XRAY T2

#302655 BALL END 4.9MM WITH THREAD 10MM (2)

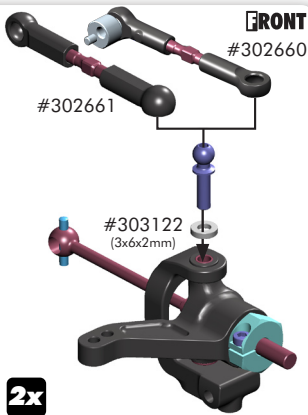
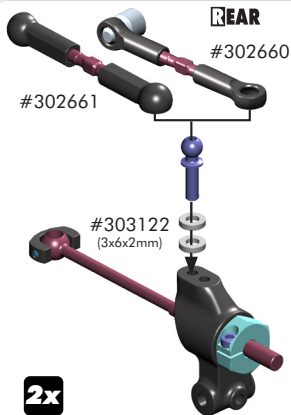
The new ball ends are developed for higher roll center use. Due to the length of the thread on the new ball ends, a minimum 4mm shim must be used in the rear and a minimum 2mm shim in the front.

The new #302661 closed ball joints must be used with the new #302655 ball ends (optional ball ends are #302654 with 8mm thread and #302653 with 6mm thread). However, the new ball ends are designed to be used with standard #302660 open ball joints as well.
